TS:22:03009
UFC:5822.00

Subject: REVISION 25 OF THE TRUPACT-II SHIPPING PACKAGE APPLICATION,
DOCKET NO. 71-9218, AND REVISION 8 OF THE HalfPACT SHIPPING
PACKAGE APPLICATION, DOCKET NO. 71-9279
(EPIDS L-2021-LLA-0033 AND L-2021-LLA-0034)

The responses to the questions submitted in Reference 6 are provided in Attachment A (Reference 7). New changes to the documents are summarized in Attachment B and are indicated by right-bars in the margin of the documents (“|”). Right-bars in the margin of the documents (“|”) indicating technical changes made to the documents in the original submittal and the subsequent amendments of this application (References 2, 4, and 5) have also been retained with this submittal.

Figure 5 – SC-30G2 Gamma Scan Grid Layout Beyond the Payload Cavity

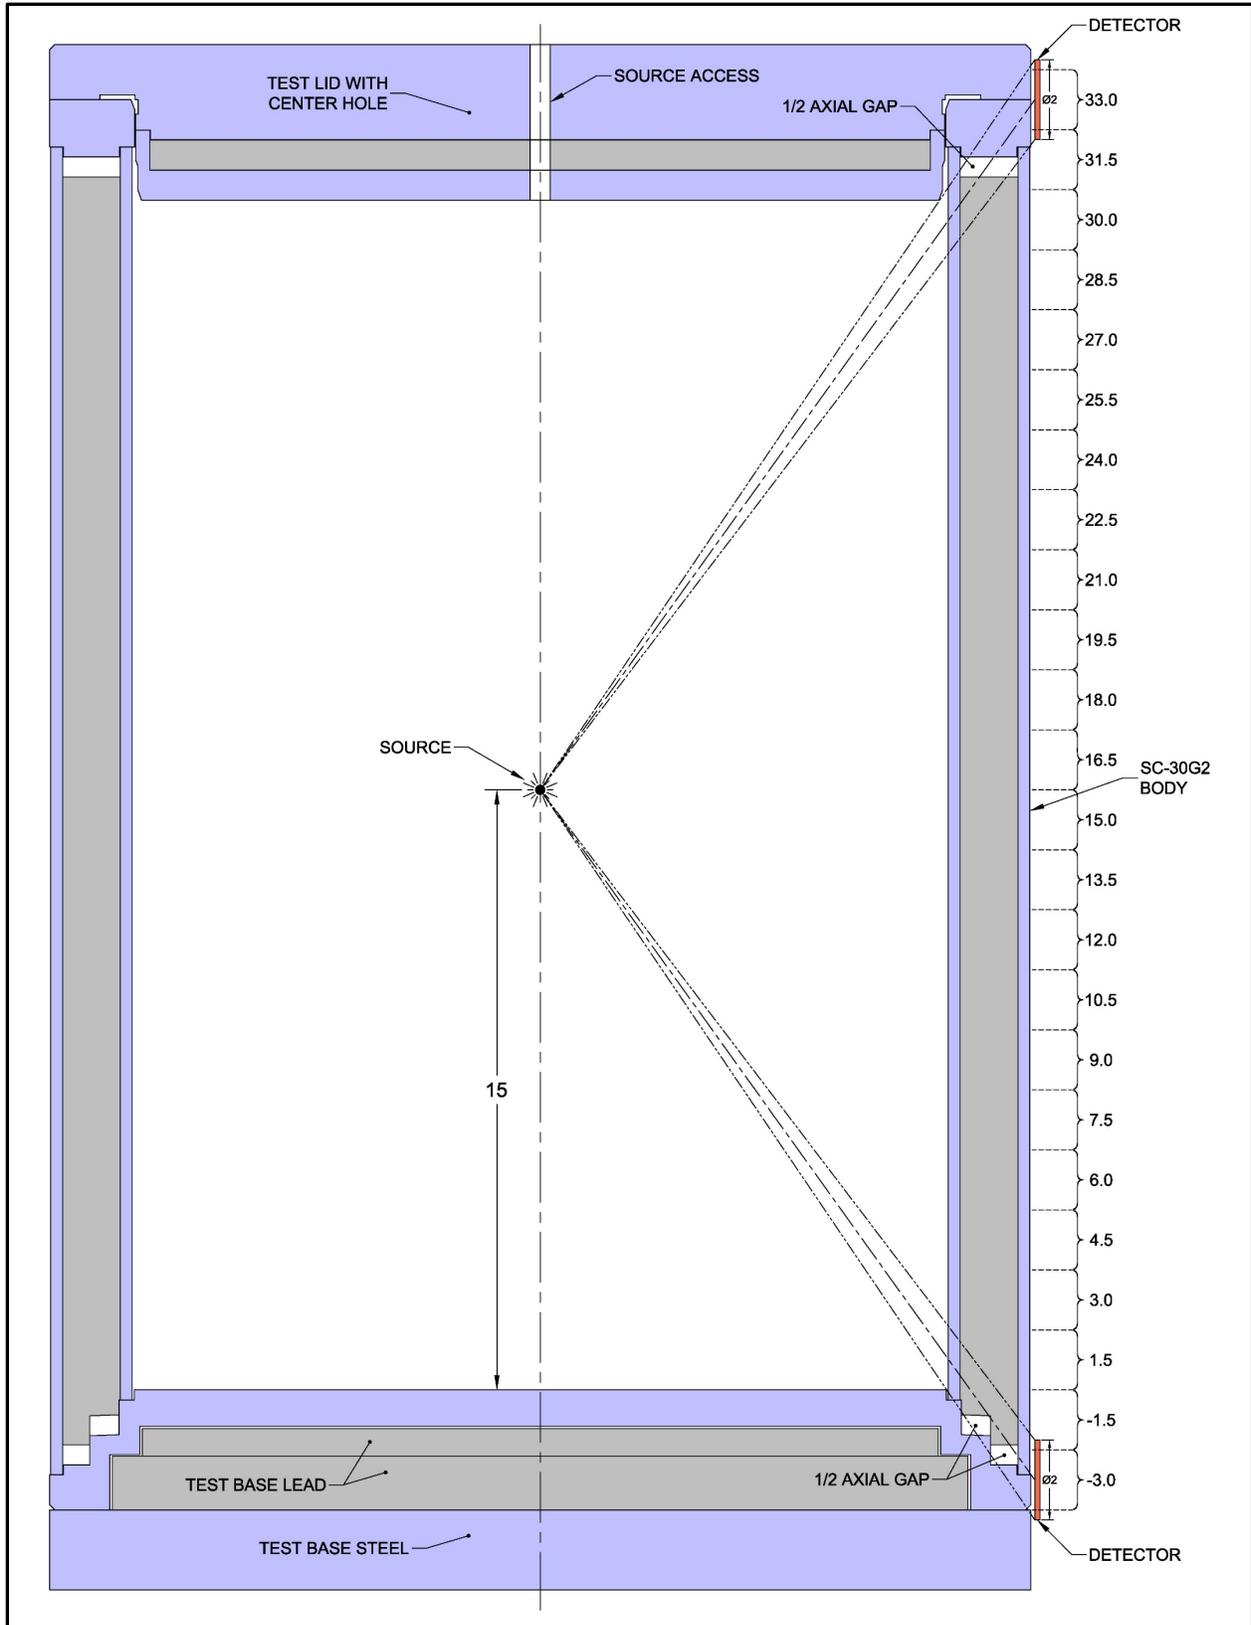
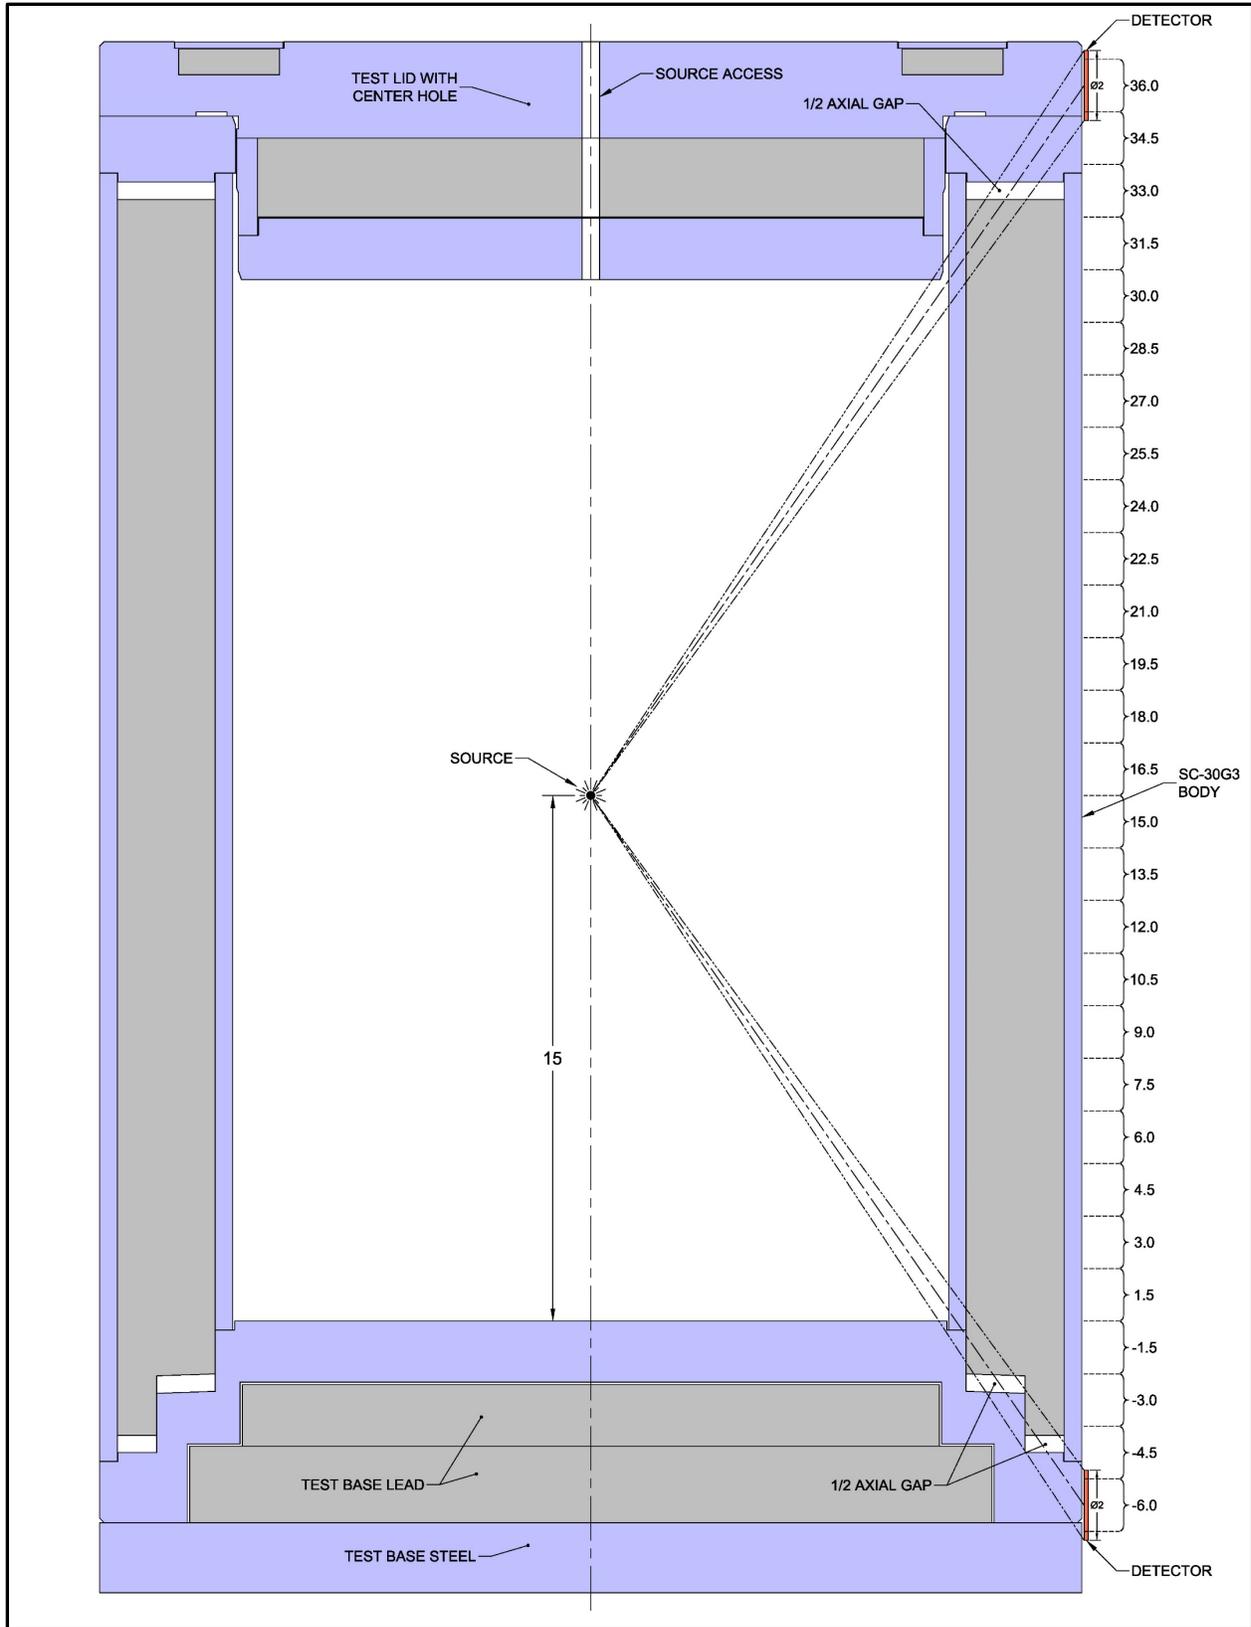
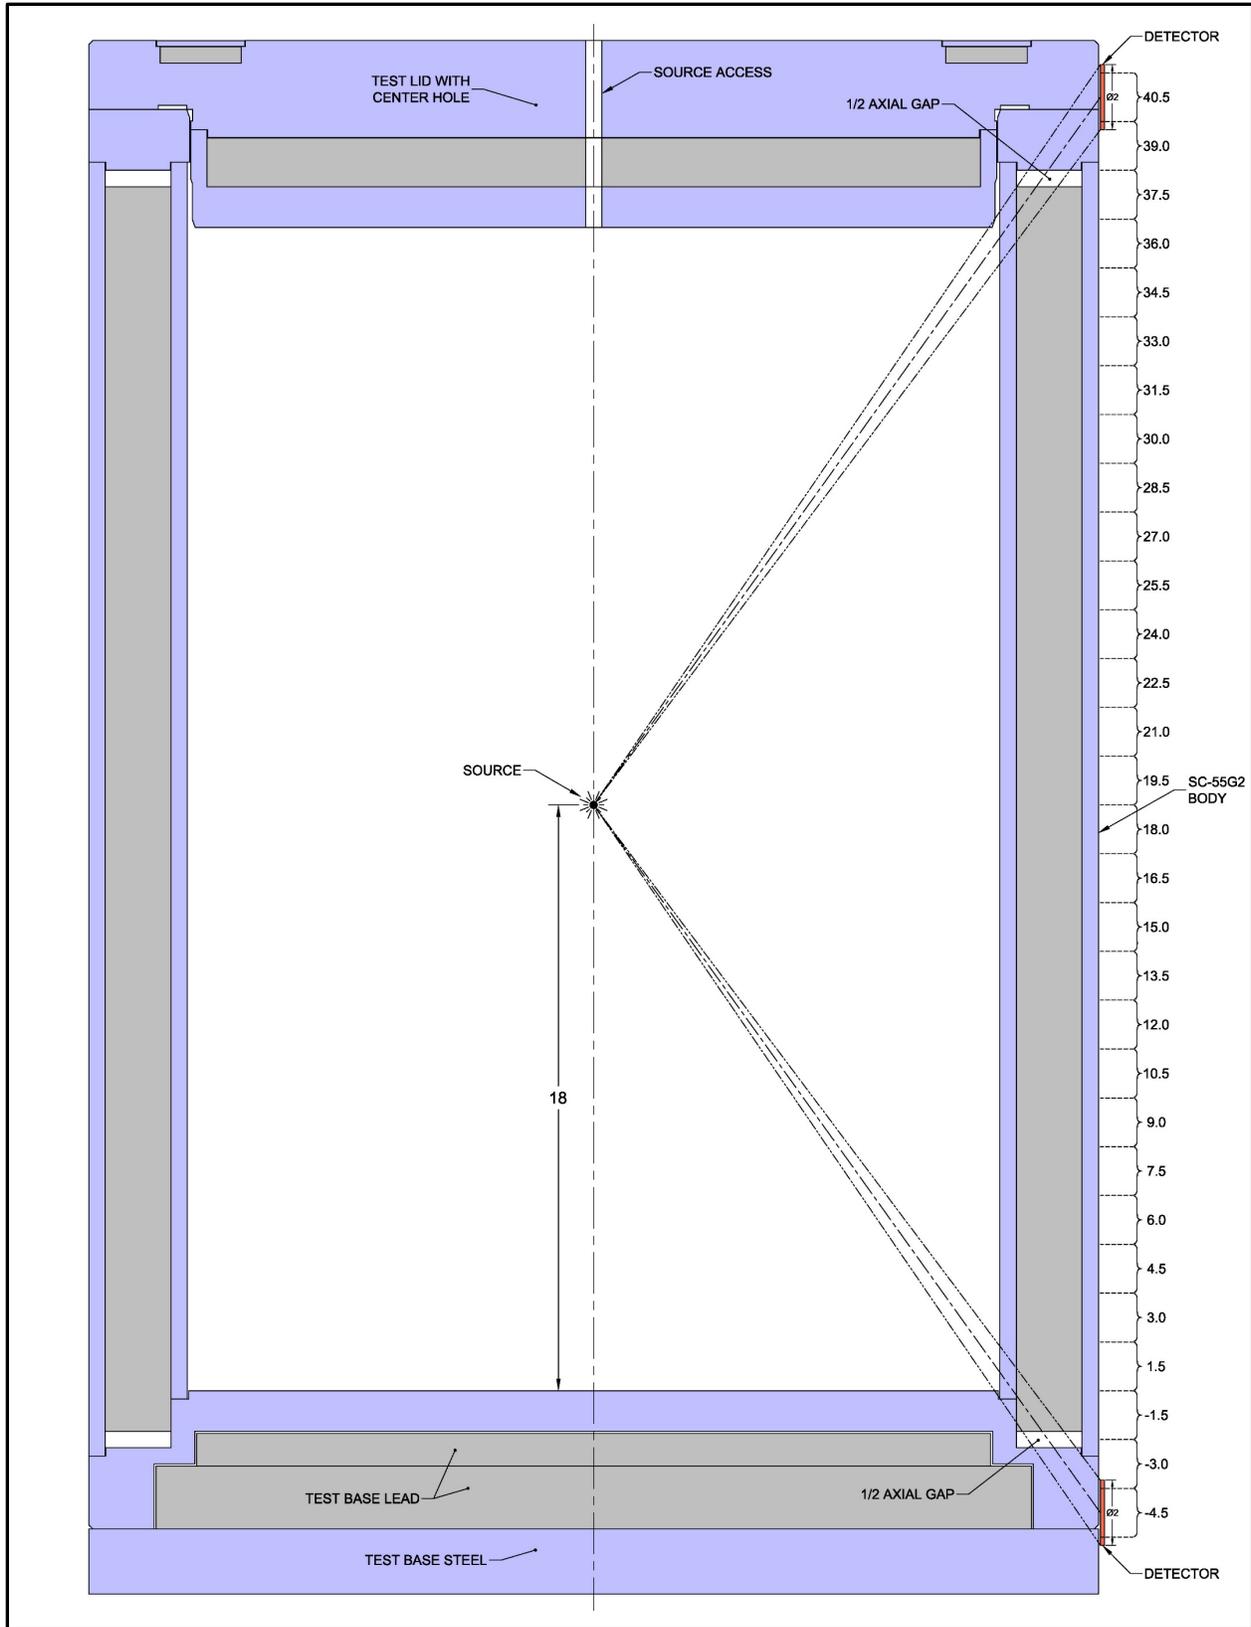
4. Explain how the gamma scan will be used to measure the thickness of the lead shield in the corners of the shielded container. If the gamma scan is not used, explain how you ensure that the thickness of the lead in the corners of the shielded container are within the values shown in the licensing drawings.

For axial grid locations below and above the payload cavity, however, the gamma scan procedure will be revised to include measurements for shielding efficacy using the following steps:

- a. Establish a source position above the bottom of the payload cavity that allows angled dose rate measurements beyond the payload cavity, including measuring for the presence of axial gaps in the sidewall lead. Figure 5, Figure 6, and Figure 7 for the SC-30G2, SC-30G3, and SC-55G2, respectively, show the detector in its lowest and highest grid positions for detecting the presence of axial gaps at the ends of the sidewall lead column. The detector in the three figures is assumed to have a relatively standard, 2-inch diameter scintillator face.

- b. Create MCNP models of the prototypic gamma scan test configurations for the SC-30G2, SC-30G3, and SC-55G2 designs with minimum material conditions, i.e., minimum steel shell and sidewall lead thicknesses, including the presence of a 1/2-inch axial gap at both ends of the sidewall lead column. The model will include a test base and lid, as described in the previous response; both are reusable for gamma scan testing all units of that size.

- c. Run the three MCNP models for a unit source strength of ^{60}Co and ^{192}Ir (the two most commonly used radionuclides for gamma scan testing) for a straight-through-the-wall baseline case, then for the “slant-shot” grid rows below and above the payload cavity. For example, with reference to Figure 5 for the SC-30G2, the below and above grid locations are -1.5, -3.0, 31.5, and 33.0. An RCR adjustment factor can be applied to these slant-shot grid rows by calculating the ratio of the slant-shot unit dose rate with the straight-through unit dose rate for each grid row.

Section 8.1.5 of the HalfPACT Safety Analysis Report will be revised to summarize the above process for slant-shot gamma scan testing beyond the payload cavities for the SC-30G2, SC-30G3, and SC-55G2 containers.
